| NRC [Letter 108 RAI \(Seismic Hazards\) Dated March 15, 2012](#)

| [Progress Energy Response L-0998 to NRC RAI](#):

**Levy Nuclear Plant Units 1 and 2
COL Application
Part 2, Final Safety Analysis Report**

Revised Figure 2.5.2-296: Horizontal and Vertical Scaled GMRS for the LNP Site.

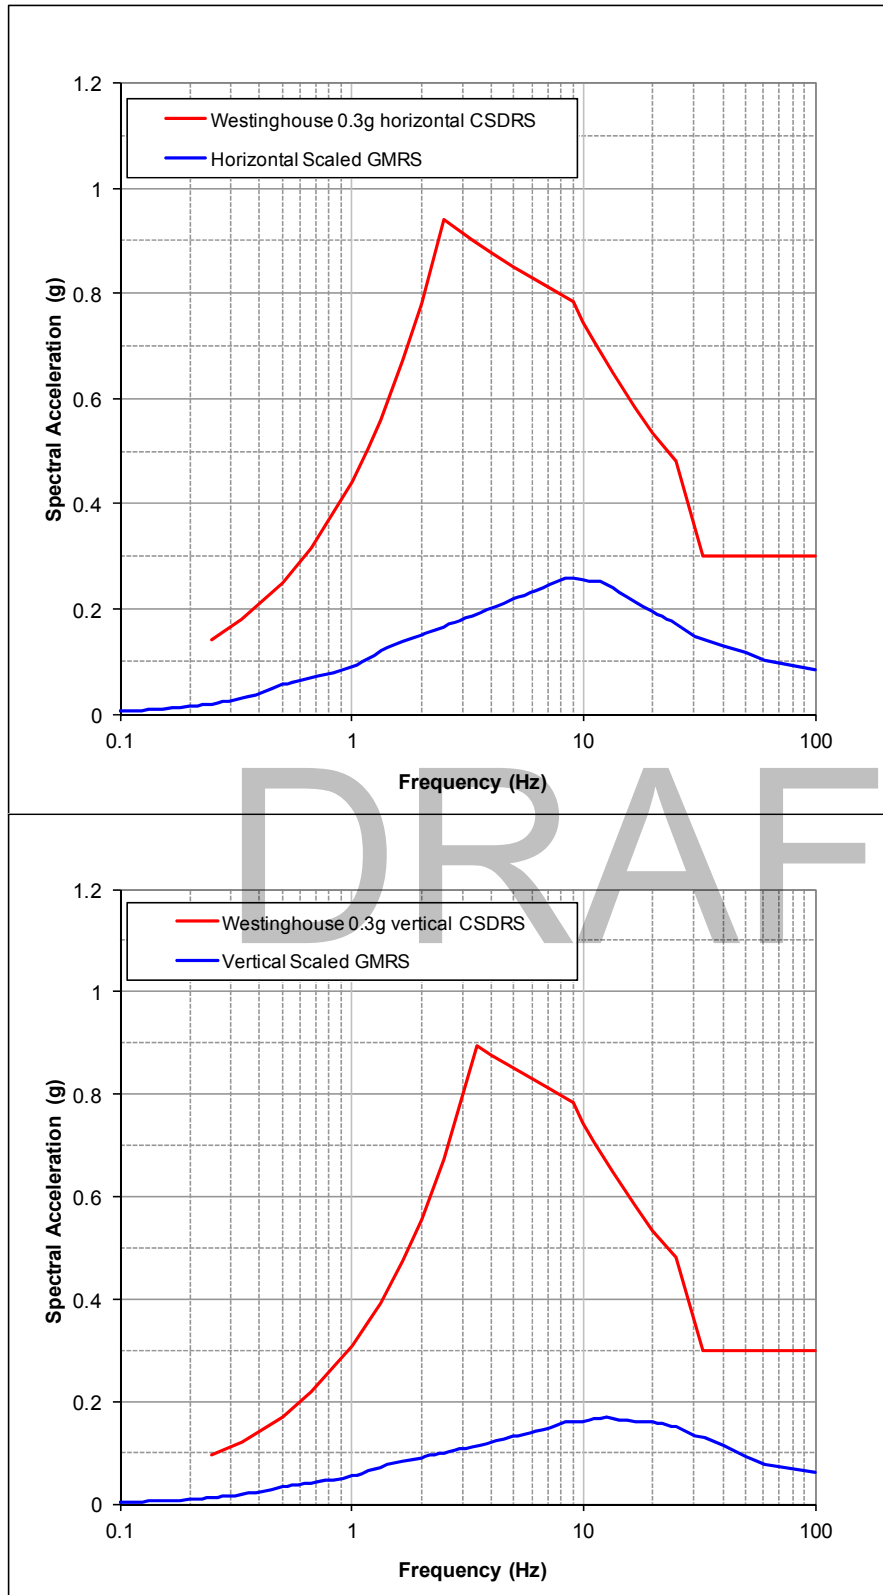
For site specific evaluations and design (liquefaction evaluations, seismic interaction of the AB, TB, and RB with the NI, Soil Structure Interaction analysis of the NI, and the design of the RCC bridging mat), scaled PBSRS and scaled FIRS (EL +11 ft.) are used. The scale factor of 1/0.825 was used so that the FIRS has a zero period acceleration of 0.1g as required by 10 CFR Part 50 Appendix S. To be consistent with the site specific evaluations and design, the GMRS was also scaled by the 1/0.825 factor. The scaled horizontal and vertical GMRS are presented in Figure 2.5.2-296. The scaled GMRS represents the licensing basis GMRS for the LNP site.

The scaled horizontal and vertical GMRS are compared to the Westinghouse Certified Seismic Design Response Spectra (CSDRS) on Figure 2.5.2-296. The site scaled GMRS are enveloped by the CSDRS.

The [scaled](#) horizontal and vertical GMRS are compared to the Westinghouse Certified Seismic Design Response Spectra (CSDRS) on [Figure 2.5.2-296](#). The site [scaled](#) GMRS are enveloped by the CSDRS.
